According to provisions of 10 CFR 2.206, I hereby petition the NRC to perform *de novo* reviews of ballooning (swelling) and rupture models used in licensees' loss-of-coolant accident analyses required by 10 CFR 50.46, and further to require licensees to incorporate any modifications needed to obtain NRC approval and then use only such models that have been so reviewed and approved by the NRC in all such licensing analyses.

### The Issue

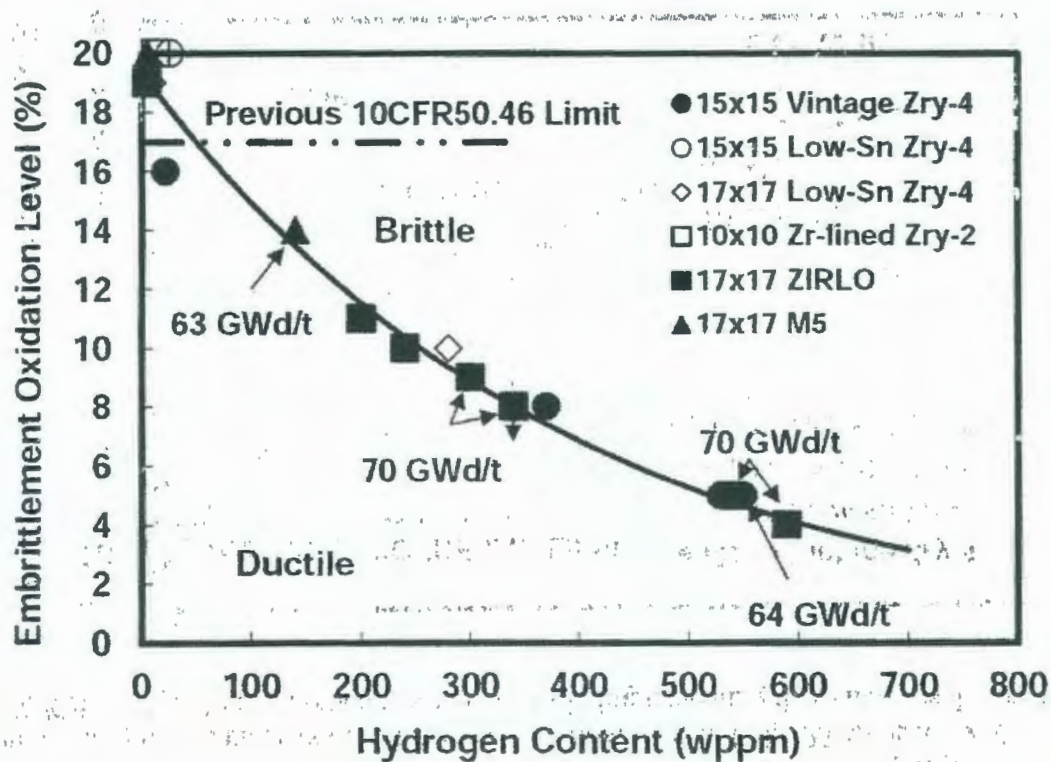
Recent research results show that the limiting oxidation level for high-burnup fuel will be far below the 17 percent limit prescribed by 10 CFR 50.46 as seen in the following figure (unnumbered figure on page xxxii of the Executive Summary and Fig. 25 on page 59 of NUREG/CR-7219). Relaxed schedules and delays in implementing these new results are based

on a safety assessment and audit which confirmed that sufficient safety margin exists for operating reactors and determined that immediate regulatory action was not required (Clifford to Ruland, February 10, 2012, ML12041A078). This assessment was based on industry calculations with models that may be flawed because of inadequate ballooning and rupture models.

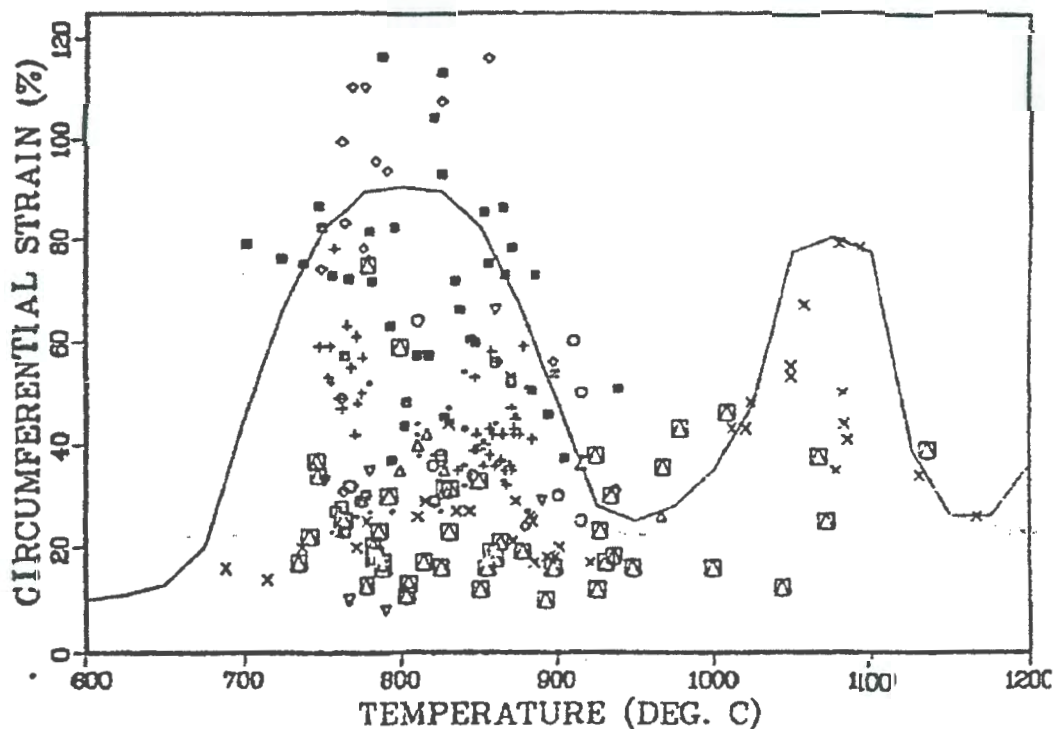
In light of recent research results, the ballooning and rupture models used in licensing analyses to calculate ECR are probably non-conservative. The basis for this statement can be explained with the following figure from NUREG-0630. This figure shows the size of the balloons (larger balloons have thinner walls) as a function of rupture temperature for fresh or low-burnup Zircaloy. There are two peaks: alpha-phase cladding on the left and beta-phase cladding on the right. The valley in the middle is in the mixed-phase region. It was previously believed that fill pressures could be engineered such that rupture would occur in the mixed-phase valley and therefore balloons would be relatively small. Most or all current ballooning and rupture models used in licensing predict relatively small balloons. This was not considered a concern by NRC because ECR was seldom if ever limiting and a more critical review seemed unnecessary.

The second finding is that the peaks-and-valley character of balloon size, as shown in the above figure, shifts along the temperature axis with the addition of niobium to zirconium in the more modern ZIRLO and M5 cladding materials. Although we now know that niobium causes a shift, there are not enough data to define the new peaks and valley for ZIRLO and M5 such that one could claim that ruptures only occurred in the valley.

Finally, one should recognize that the curve drawn through the scattered data in the above figure is a best estimate and was not intended as a conservative representation of the data. As an author of that report, I know that many of the tests that resulted in smaller balloon sizes had atypical test conditions that biased their results. Therefore, we drew the best-estimate curve through the larger balloon sizes. Thus, any model that predicts ballooning strains less than about 90%, based on the above figure, should be suspected of being non-conservative.

It is well known that rupture results from a plastic instability that is set off by local temperature hot spots. There are many causes of local temperature variations that lead to the unpredictable character of the rupture process, as seen in the large data scatter in the above figure. Mechanistic models cannot represent the stochastic nature of this process. Therefore a statistical approach, which represents all of the data without favoring strains in the mixed-phase valley, is probably needed and should provide some modest conservatism of the ensemble of data.
